ADDENDUM NO. ONE (1)

Date: 01/29/2026 Architect's Project No. A24-129GSB

Project: DoSS Office Build Out, Addition, & Site Development Project, BL141-25

Client: Gwinnett County

CONCRETE FLUME DETAIL

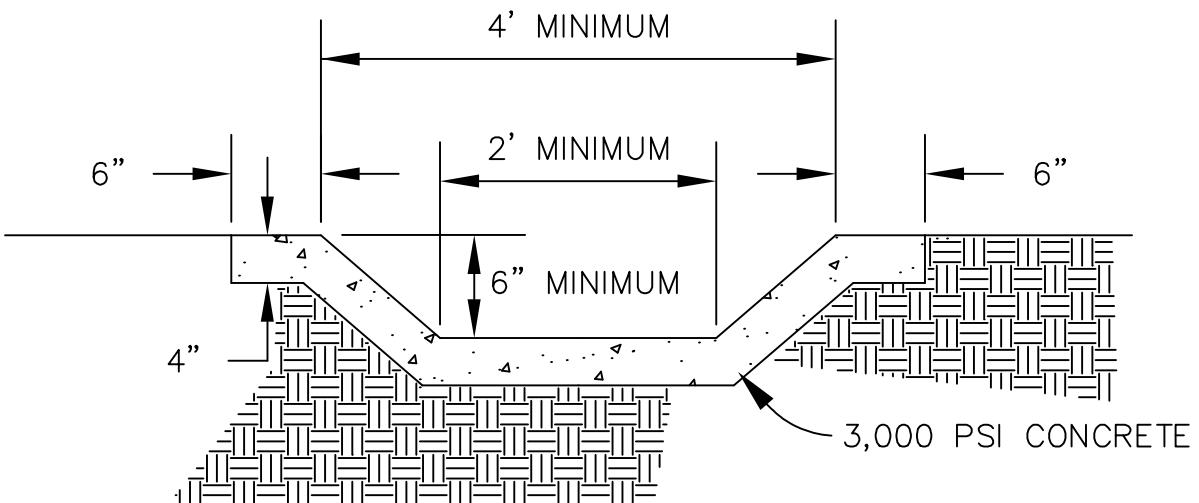
Q99. **Concrete Flume; Could you provide a section view of the concrete flume? Aggregate Base needed below?**

A99. Refer to the attached concrete flume detail.
